ADDENDUM #1
for
NOTICE TO BIDDERS
2019 STORMWATER IMPROVEMENTS
HUMBOLDT WASTE MANAGEMENT AUTHORITY
Bid Date: Wednesday, May 1, 2019

This is an Addendum to the 2019 Stormwater Improvements Notice to Bidder bid documents with a bid open date of May 1, 2019. The following questions were received to the Humboldt Waste Management Authority (HWMA) office prior to the deadline of 4:00 p.m. (PST) on April 24, 2019. **Please reference this Addendum in your submitted bid proposal.**

STANDARD DRAWING
PRECAST REINFORCED SEPTIC TANK-THICK WALL 1500 GALLON CAPACITY
 SPECIFICATIONS

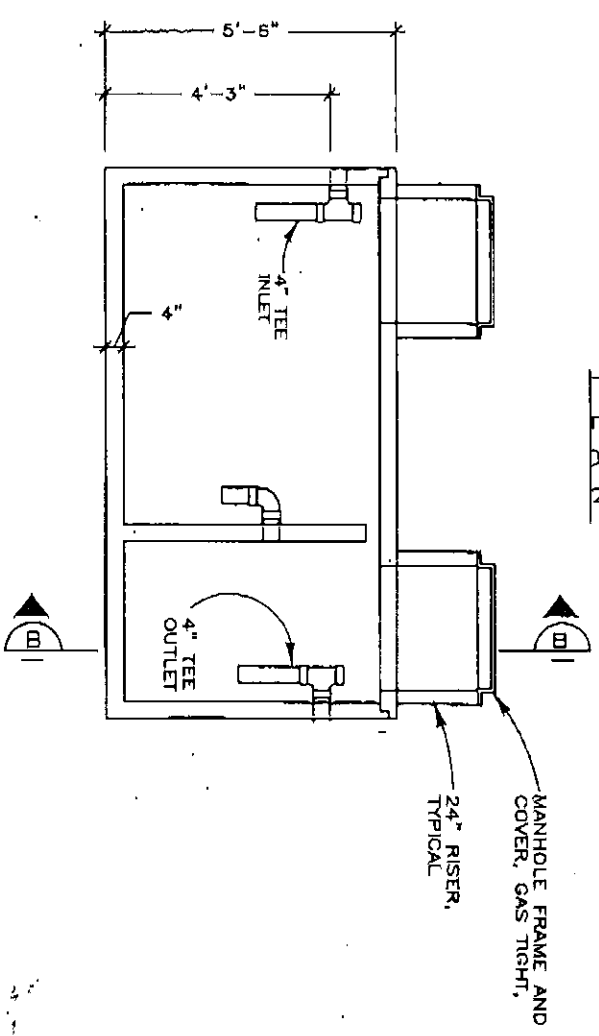
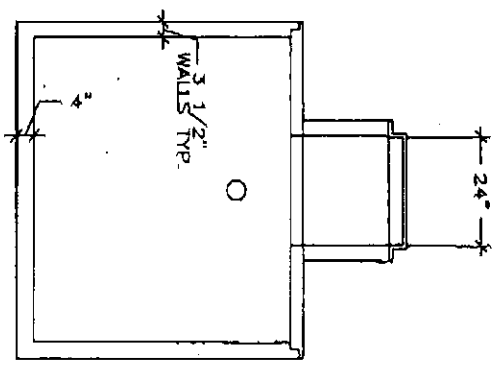
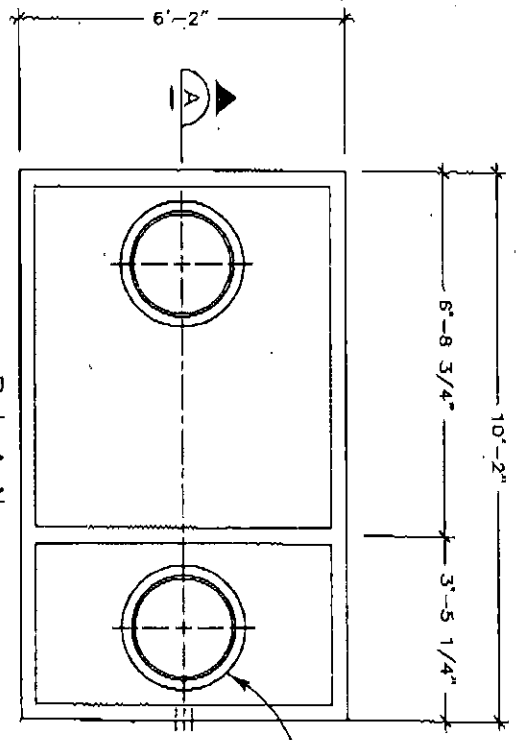
- 1. Will the use of Hilfiker precast tanks be accepted as equal? See attached "Hilfiker 1500.pdf".*

2. *Will two 1,500 gallon tank installed in series be accepted in place of the 3,000 gallon system?*

3. *Will a 1,500 gallon tank be accepted in place of the 2,000 gallon system?*

Response: This question is understood as relating to an equivalent storage tank for the 3,000-gallon and 2,000-gallon capacity precast clarifier tanks indicated in the Bid Documents. For the 3,000-gallon tank, two of the 1,500-gallon Hilfiker may be placed in series, as an equivalent to the single clarifier, provided that the inflow and outflow dimensions match the design drawings and the internal baffle is increased to four 4" turn-down bends.

For the 2,000-gallon clarifier shown on the plans, a similar equivalent as described above of two 1,500-gallon Hilfiker units is considered an equivalent.

No additional payment will be made for the additional excavation or construction required, or the 12" pipe connection between the two units, if the Contractor elects to utilize the Hilfiker units as an equivalent for construction.

Response: Yes, as indicated in Response #1 above.

Response: No, however, for bidding purposes, two 1,500 gallon tanks would be considered equivalent. See Response #1 above.
